SUBMISSION PM & DC BROADHEAD

INVERARY PARK, 40 BROADHEAD LANE, BUNGONIA

OBJECTION TO ARDMORE PARK QUARRY MODIFICATION (MP 07-0155 Mod 3)

FIGURE 3 SENSITIVE RECEPTOR LOCATIONS

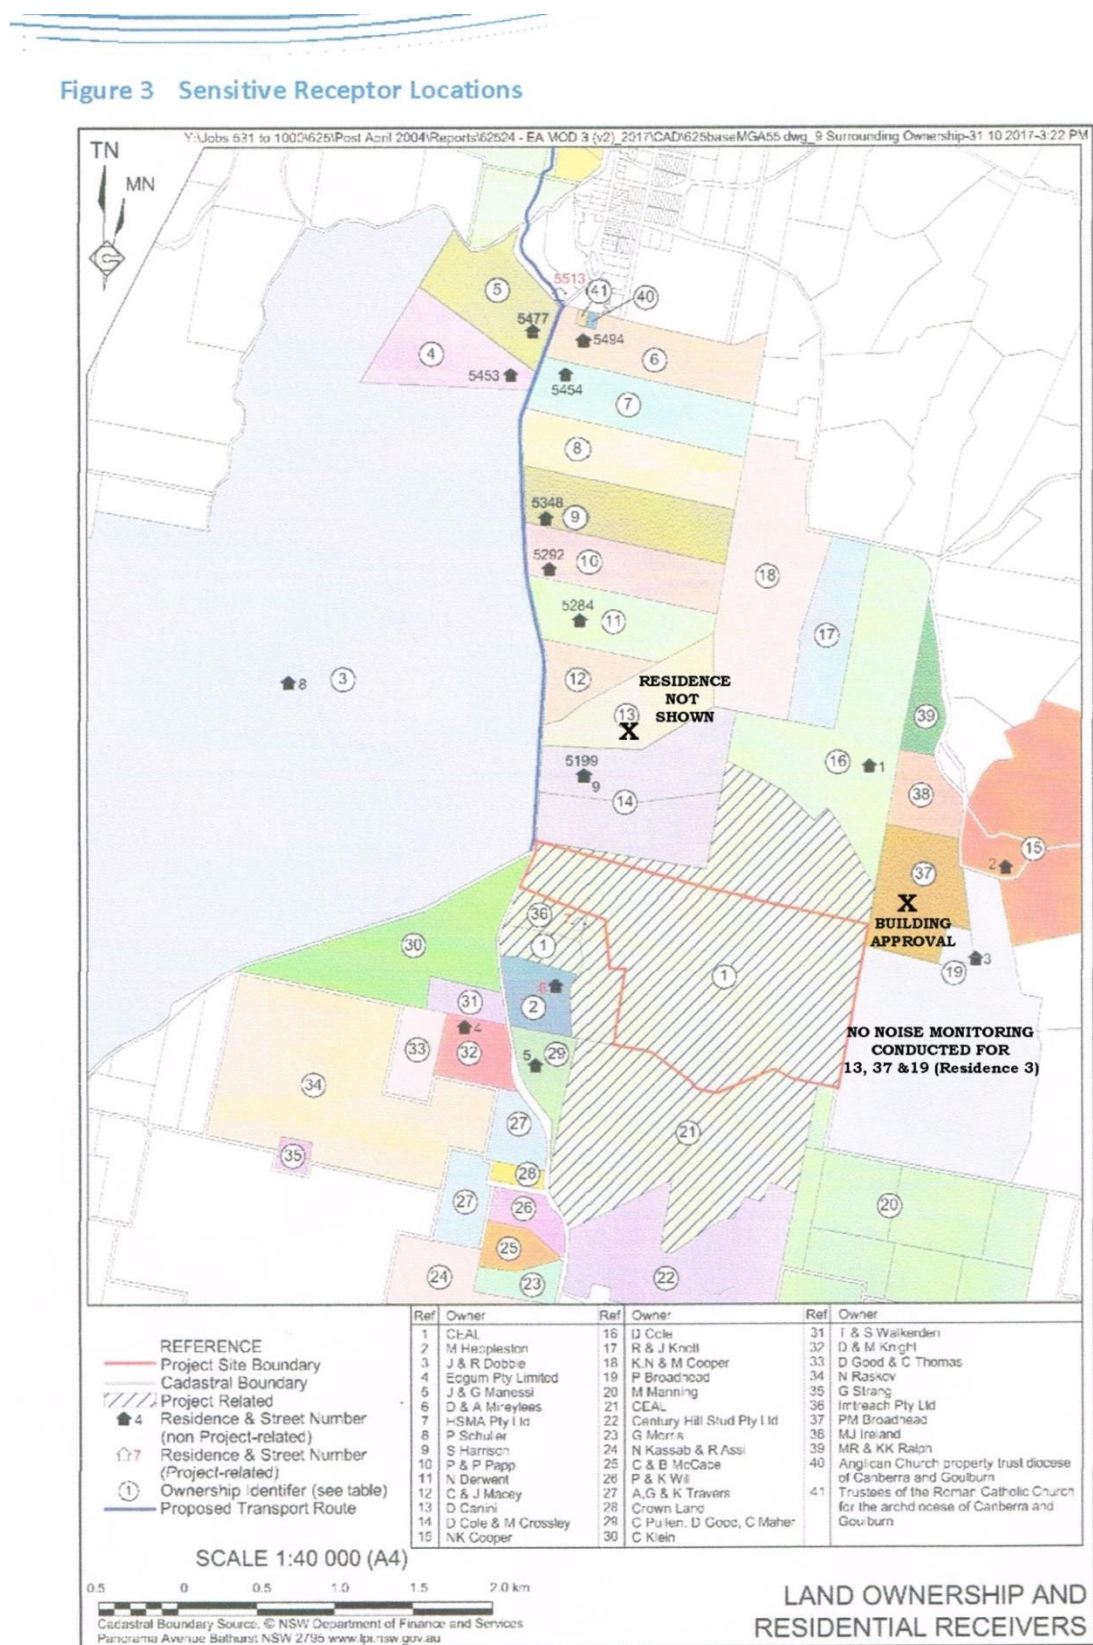
We reside at **residence 3 - Figure 3 Sensitive Receptor Locations** (See Appendix 7 – Noise Impact Assessment – see below) which is approximately **700 metres** from the eastern property boundary of Ardmore Park Quarry. (Spatial Information exchange <https://six.nsw.gov.au/>)

This property has been totally ignored for any noise monitoring.

We also own vacant land at 46 Broadhead Lane, Bungonia (approx.100 acres with building approval) **Ref 37** on **Figure 3 Sensitive Receptor Locations** (See Appendix 7 – Noise Impact Assessment – see next page) which adjoins the Eastern boundary of Ardmore Park Quarry. The best building site for this property is close to power lines & pole which is approximately **300 metres** in a direct line East of the Quarry boundary. (Spatial Information exchange <https://six.nsw.gov.au/>)

This property has been totally ignored for any noise monitoring.

Further to these, we own property 5224 Oallen Ford Road, Bungonia, **Ref 13 on Figure 3 Sensitive Receptor Locations** (Taken from Appendix 7 – Noise Impact Assessment – see next page). This residence is only **445 metres** NE from the closest point of the Ardmore Park Boundary. This residence is currently rented and the dwelling has been there since 1992. In the Noise Impact Assessment (Appendix 7) - Land Ownership and Residential Residences (page 11) It has not been listed as a Sensitive Receptor even though houses further away such as Residences 1,2 & 8 have.

This property has been totally ignored for any noise monitoring.

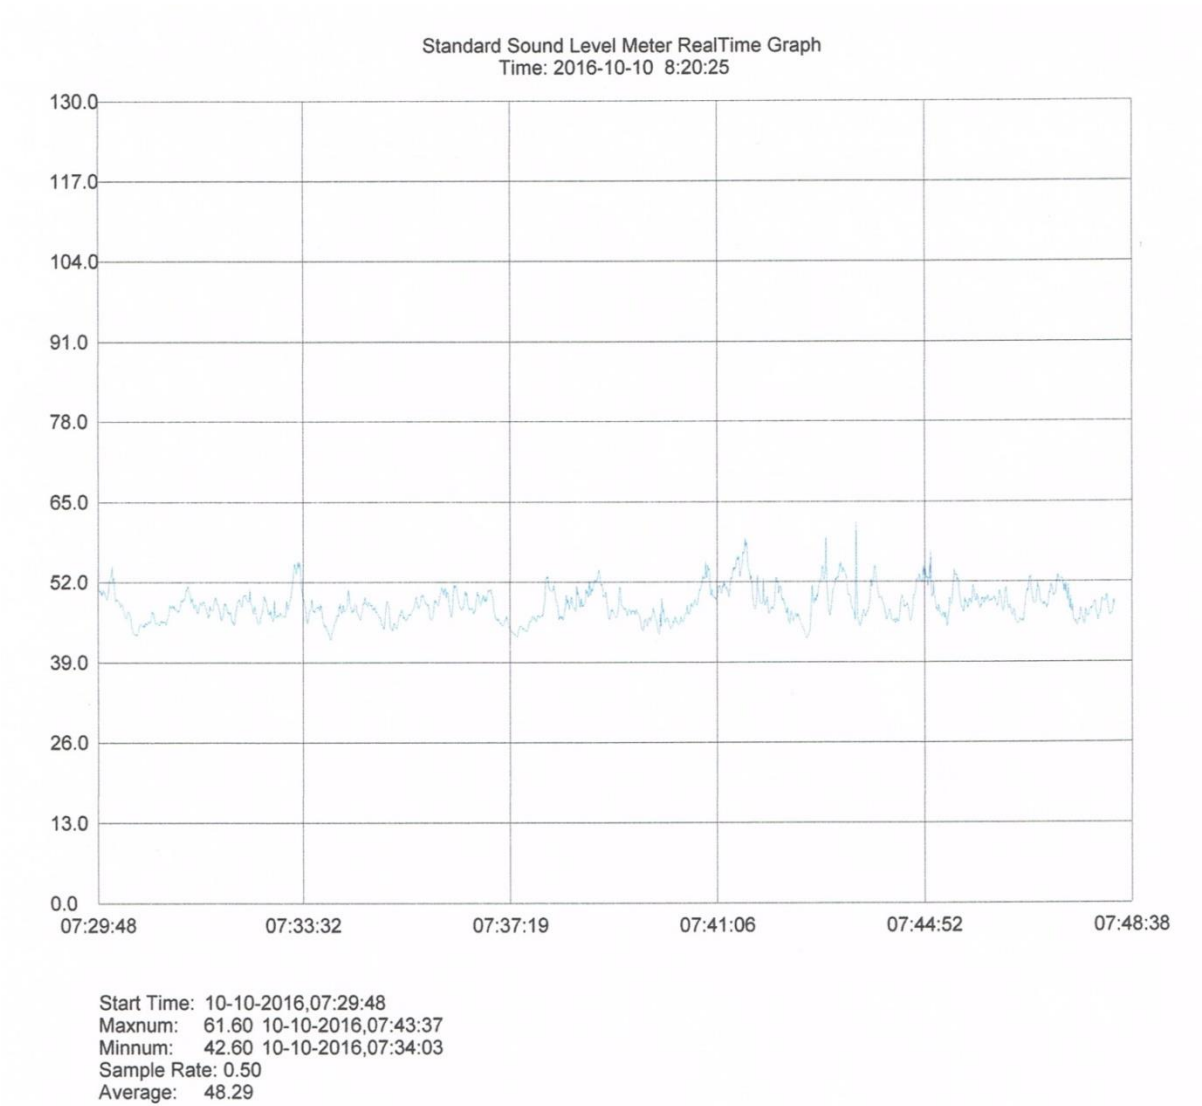
After complaints not being responded to by the quarry, we started gathering proof of the noise emanating from the Quarry and this is one recording was taken on 10 October 2016 when the Quarry was crushing hard rock. This was a noise that was becoming more frequent and we wanted proof of the levels. **Average dB 48.29**

This graph was logged on a Calibrated Digitech Sound Level Metre. It confirms to the IEC61672-1 CLASS2 for Sound Level Metres.

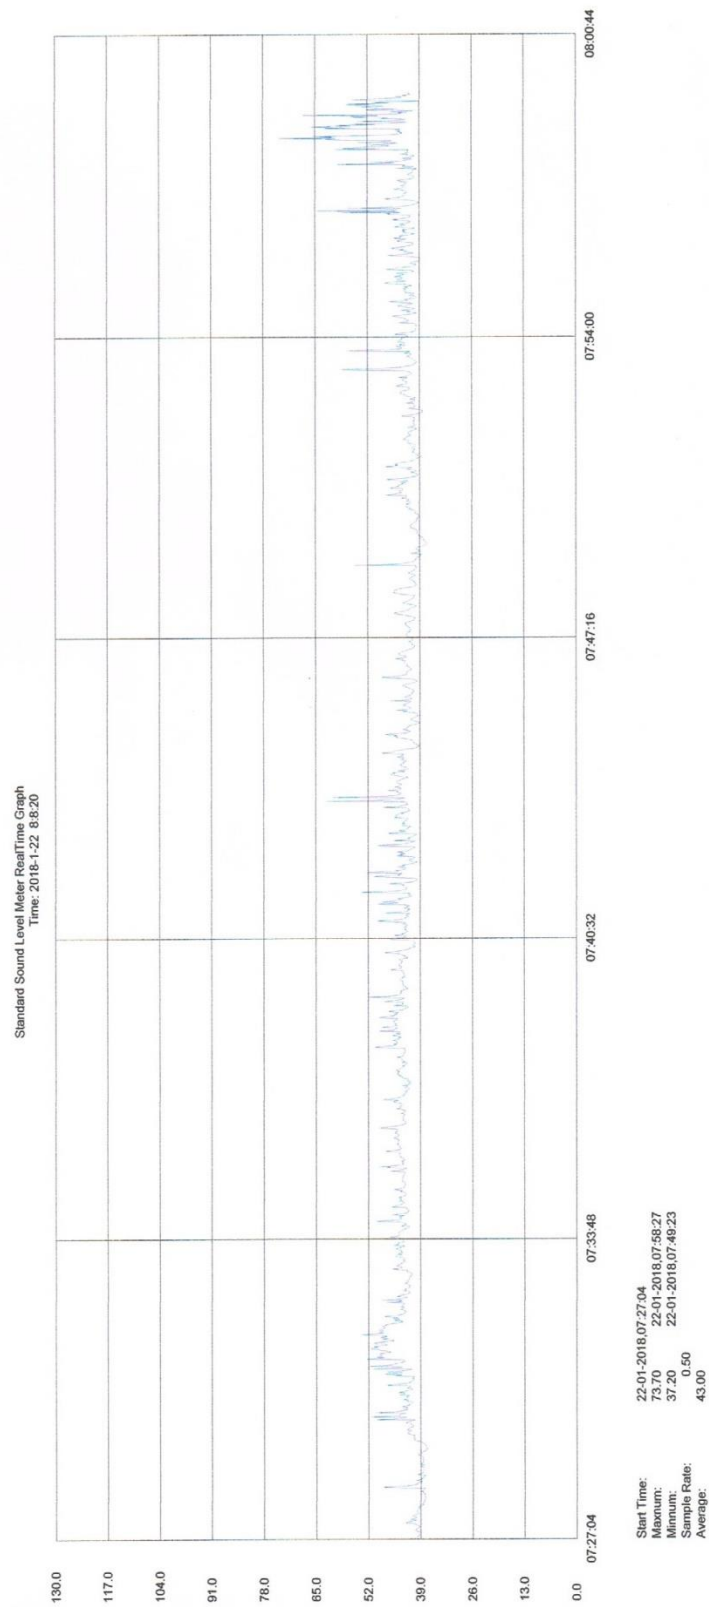
This recording was taken on 22 January 2018 when the Quarry was Sand Processing. This noise had been going for quite a few days and we wanted proof of the levels.

The average dB was 43.00

This graph was logged on a Calibrated Digitech Sound Level Metre. It confirms to the IEC61672-1 CLASS2 for Sound Level Metres.
